San Mateo County Board of Supervisor's Meeting

File Numbers: **PLN 2005-00603**

Subject: Revised Letter of Decision - File Number PLN2005-00603
Location: 21 Estrada Place, Palomar Park
APN: 051-022-420

Re: San Mateo County Planning Commission Meeting No. 1491 Item 6: 25 Estrada Place, Palomar Park;
PLN 2005-00603 -- APN 051-022-420

FIGURE 8 – Highlighted Benching

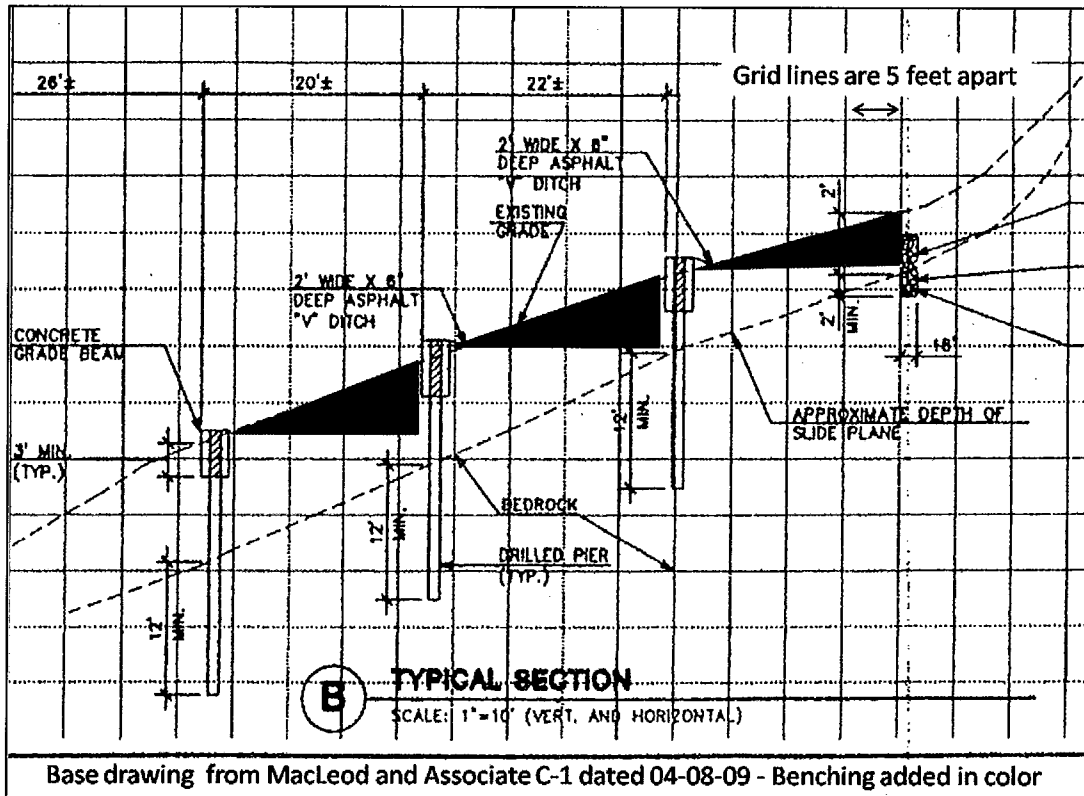
- i. ***In order to safely operate the construction equipment, won't benching between the stitch pier walls be required? (Figure 8)***
6. Based on the typical cross section from MacLeod and Associates drawing C-1 dated 04-08-09, benching for all six septic lines could be over 485CY (Figure 9). Replacing the benching to the original slope line requires 485CY of compacted fill. The approved grading amounts were only for the construction of the house and driveway.

- i. What impact would such benching have on these stitch pier walls? (Figure 8)*
8. Construction of the septic field will require feed lines from the septic tank to the lower and upper pairs of septic lines to be dug at some depth (~10 feet) under the middle and upper stitch pier wall.
